ADDENDUM NO. 1

SUBJECT: Addendum No. 1 – 600 Block of Market Street Project

PROJECT NO.: 17A-R-0625

PROJECT No.	YEAR	SHEET No.	
17A-R-0625	2017	5	
REVISIONS			
No.	DATE	BY	BRIEF DESCRIPTION
1	9-5-2018	K.M.	Added Utility Vault to be removed

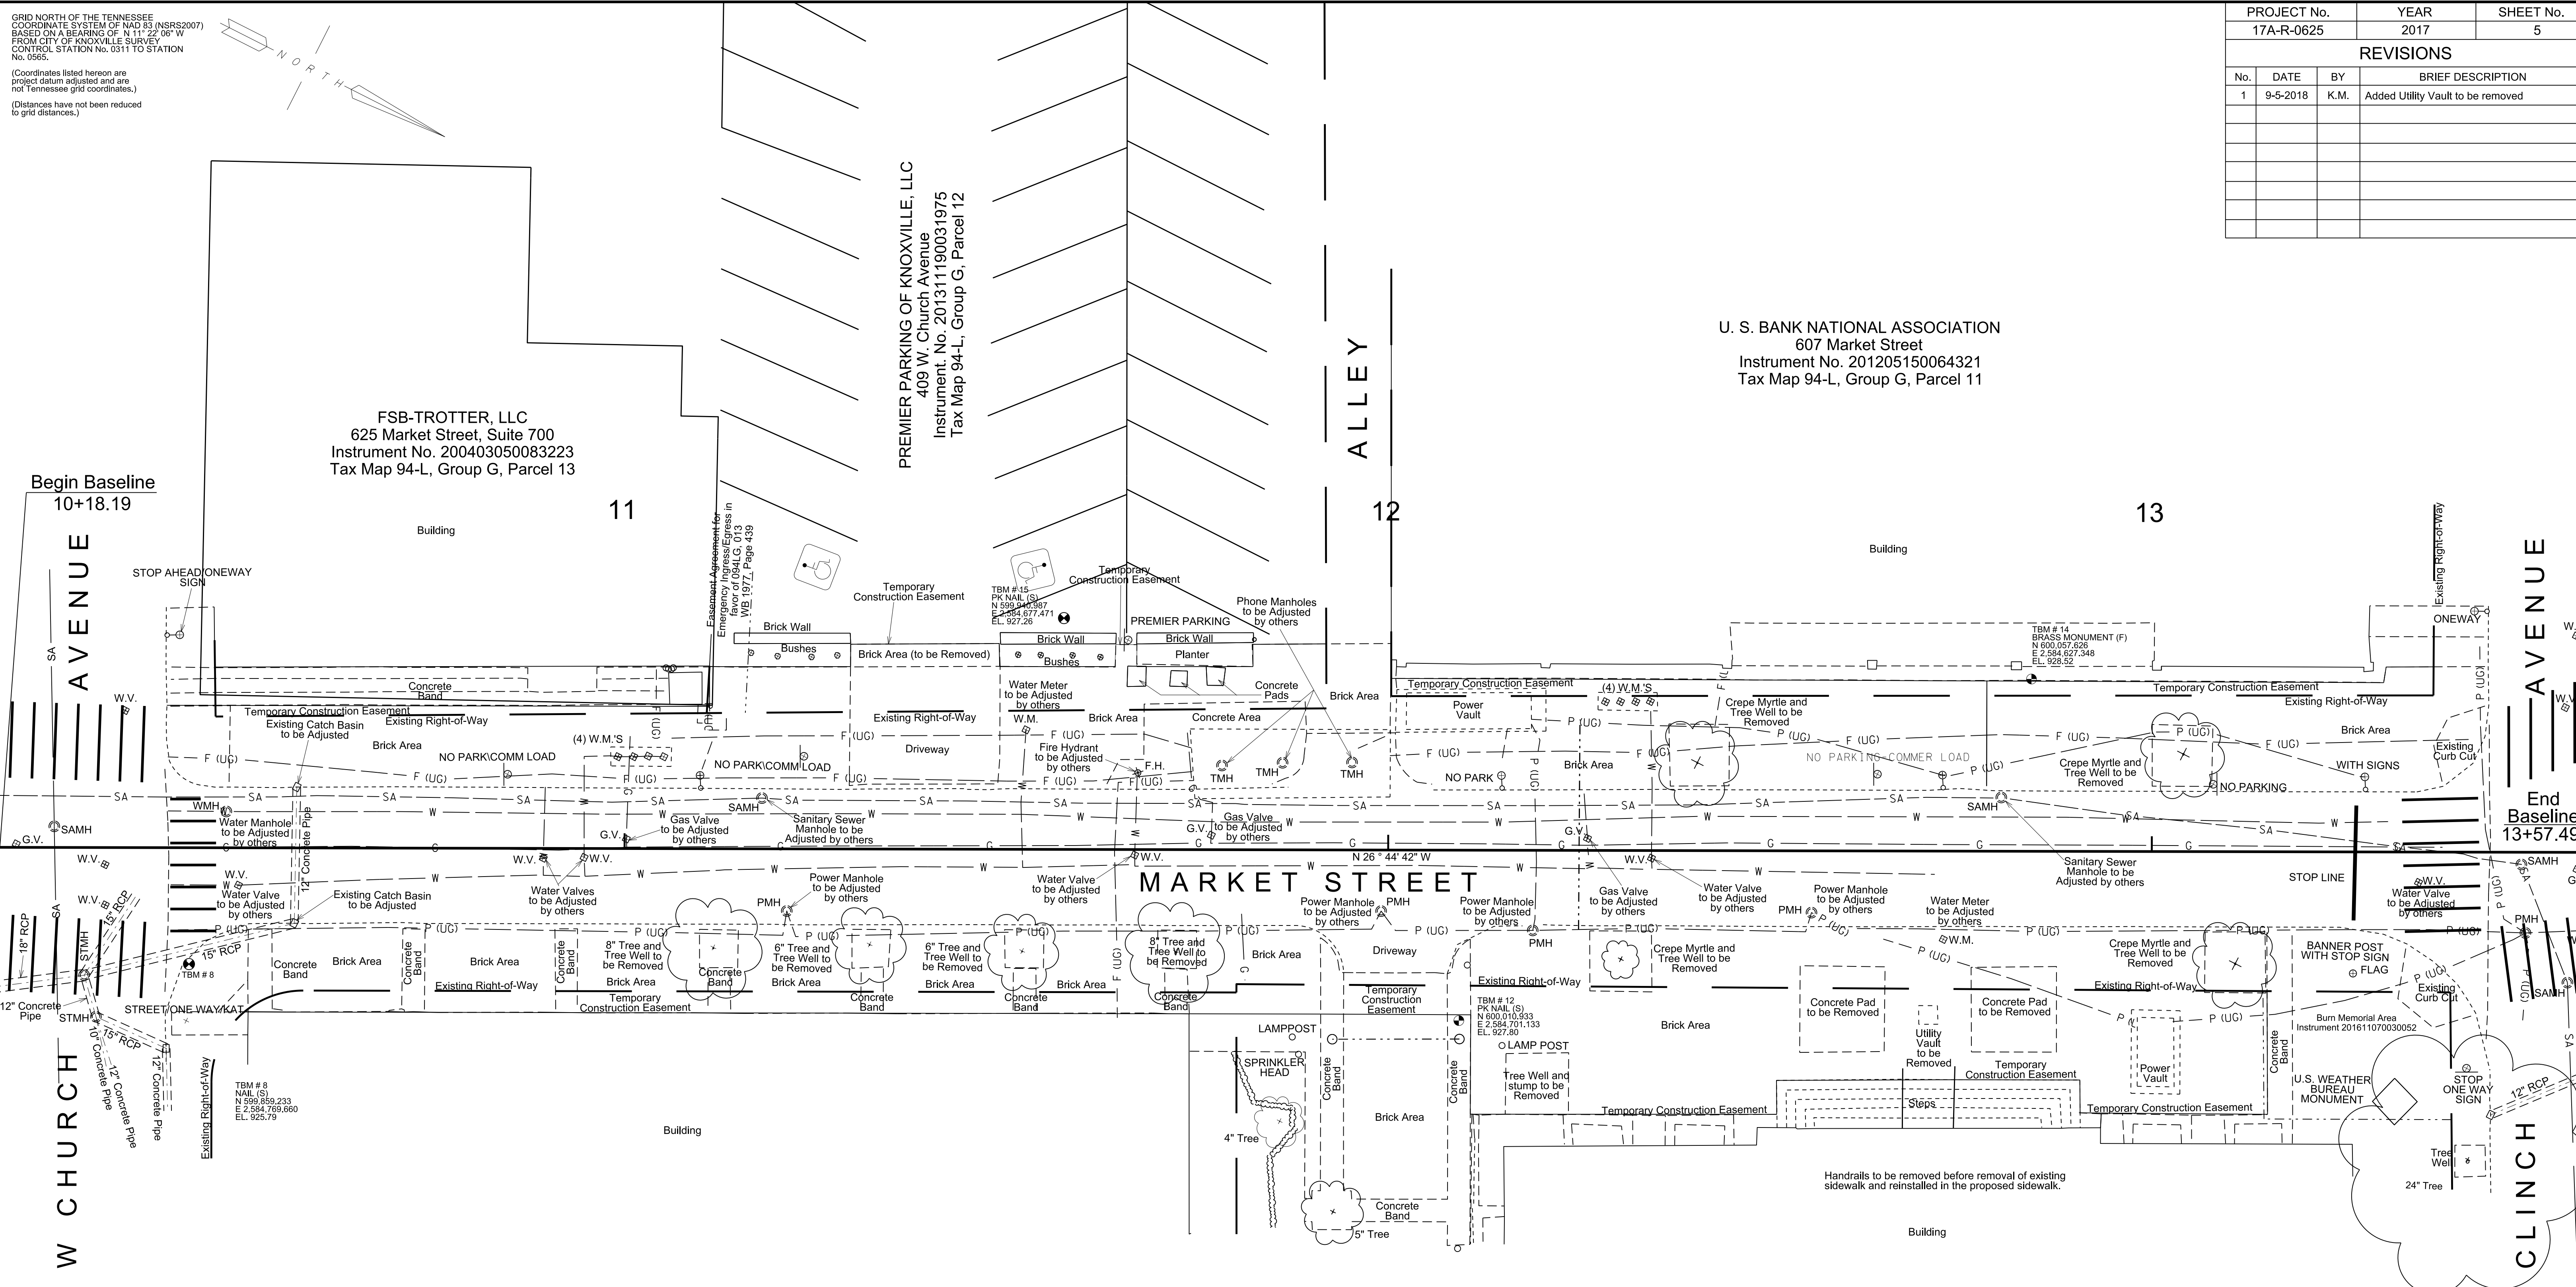
The utility vault shown on Sheet No. 5 in front of the steps to the East Tennessee History Center contains abandoned equipment related to a pump system and lighting for fountains that were formerly located on the site. A sketch from KUB showing the service to the fountains from 1967 has been included for informational purposes. Pay Item No. 23.30, Removal of Utility Vault, shall include all materials, equipment, and labor necessary to disconnect any wiring, remove the equipment, and backfill with mineral aggregate base.

Question #1: On Sheet No. 5 of the construction plans there are several utilities marked to be adjusted by others. Can you elaborate?

Response: All water, sanitary sewer, gas, and electric infrastructure will be adjusted by KUB. All telephone infrastructure will be adjusted by AT&T.

PROJECT No.	YEAR	SHEET No.	
17A-R-0625	2017	6	
REVISIONS			
No.	DATE	BY	BRIEF DESCRIPTION
1	9-5-2018	K.M.	Added Approximate Location of Basement. Removed Utility Vault. Added voids in stamp pattern around utilities.

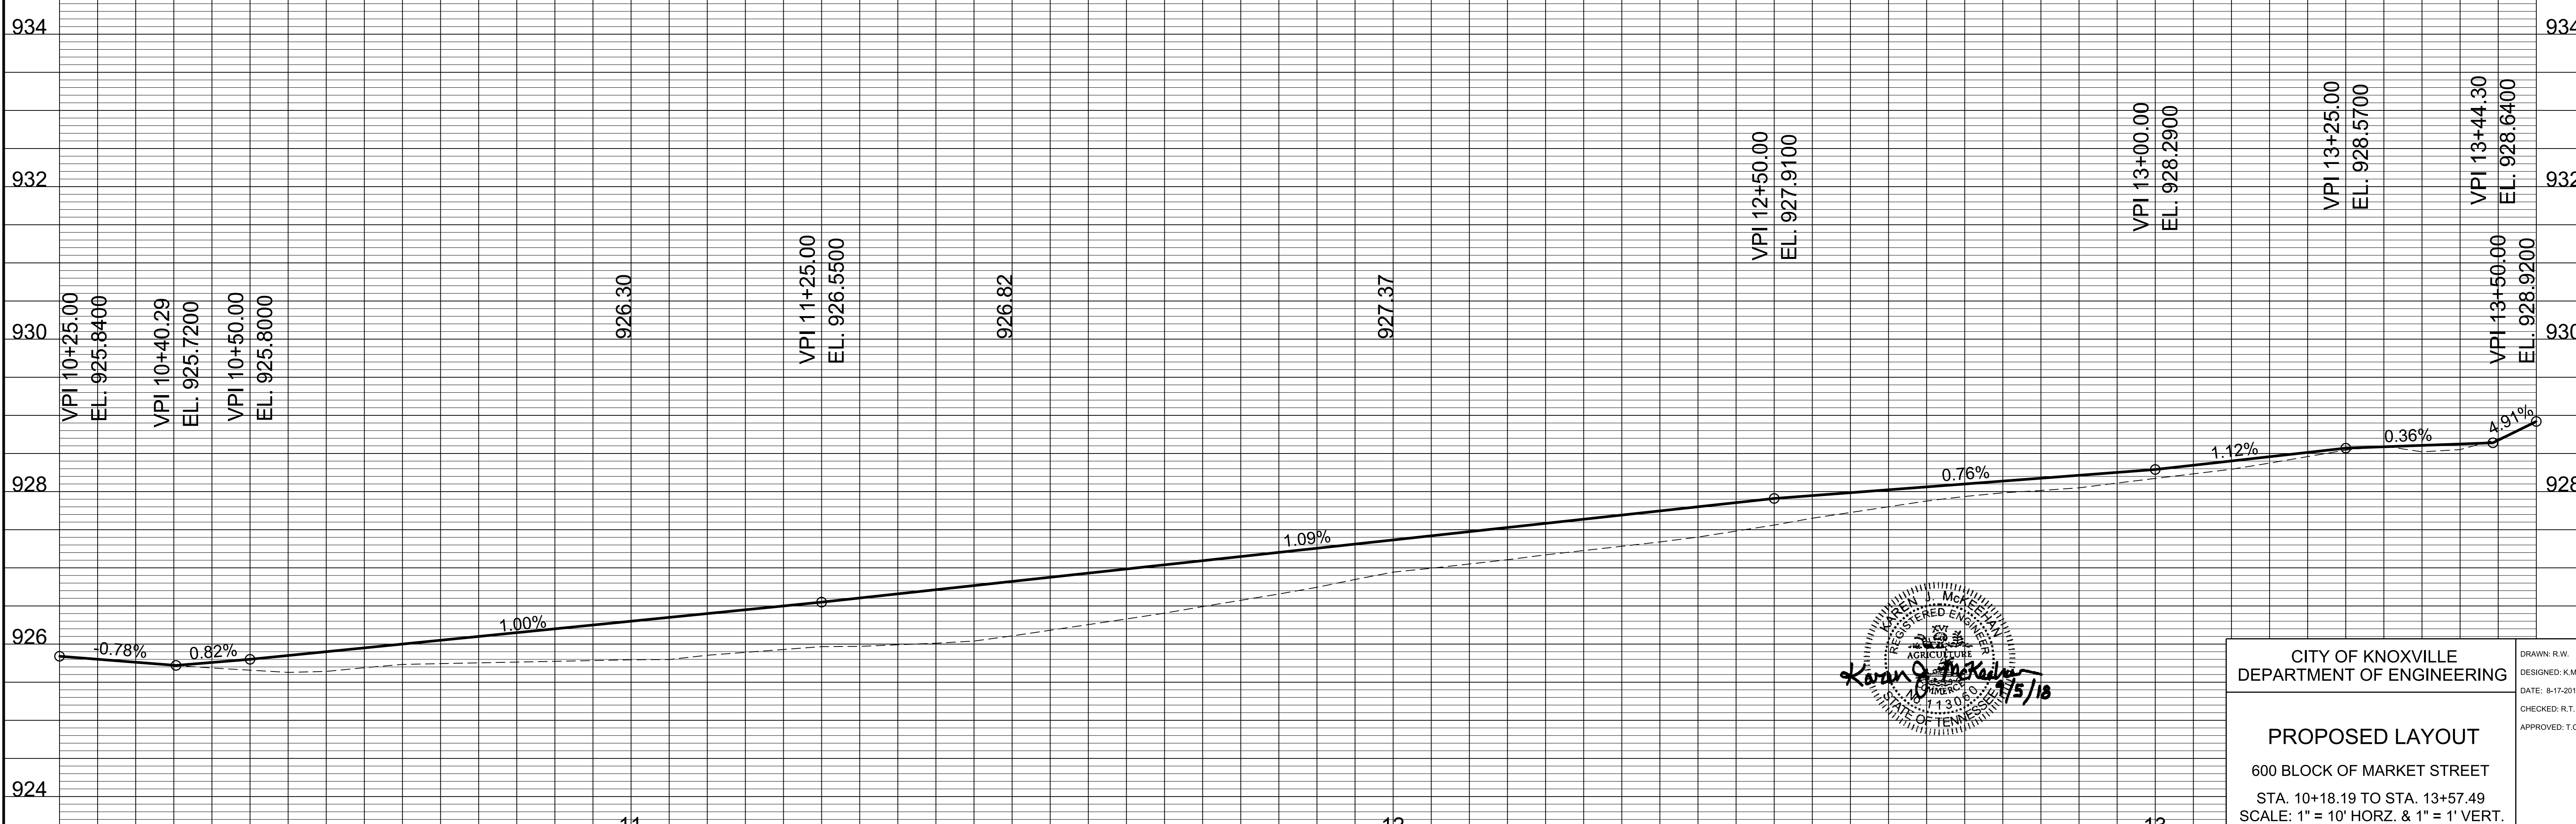
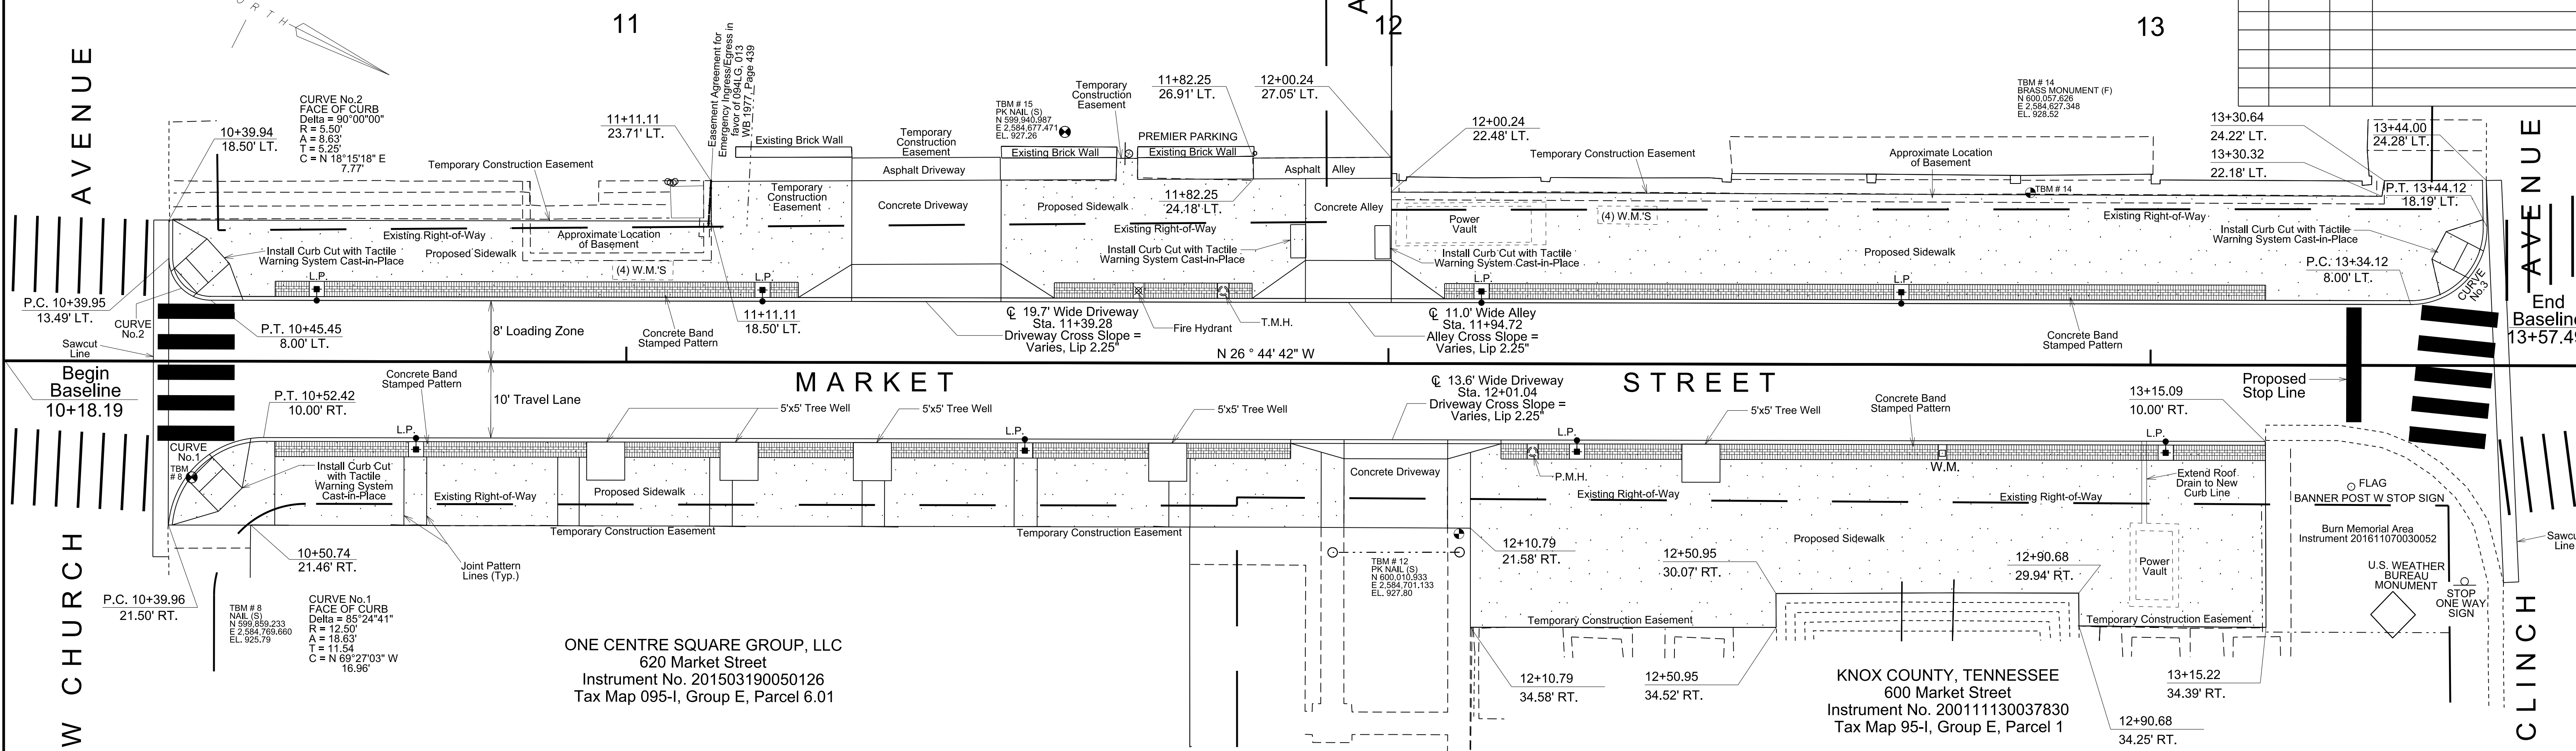
The attached revised proposed layout sheet shows approximate locations for basements under the brick sidewalk on the west side of Market Street. Basements have been identified for the Trotter Building at 625 Market Street and the US Bank building at 607 Market Street. Field investigation of the sidewalk in front of the Trotter building shows that the existing top of sidewalk is located approximately 3.25" above the basement structural slab (2.25" thick brick on top of 1" mortar bed).

The proposed concrete sidewalks that are above basements require waterproofing membrane to be applied to the cleaned and leveled concrete subbase. The attached revised proposed layout sheet shows approximate locations for basements under the existing brick sidewalks. The Contractor shall install waterproofing membrane in accordance with the attached Special Provision 17.1 for Waterproofing Membrane. All materials, equipment, and labor necessary to perform this work shall be included in the unit cost for Item No. 17.11, Waterproofing, and be paid for by the square foot.

Question #2: How will utilities affect the stamping pattern in the integrally colored concrete band?

Response: The contractor will be allowed to square off the stamping pattern and leave a void in the pattern around the base of utilities and light pole foundations as shown in the attached revised Sheet No. 6. The concrete around fire hydrants, telephone manholes, water meters, and power manholes within the band will still be integrally colored. The exposed light pole foundations will not be integrally colored, but will require a natural sand mix concrete to in order to match the adjoining sidewalk and curb.
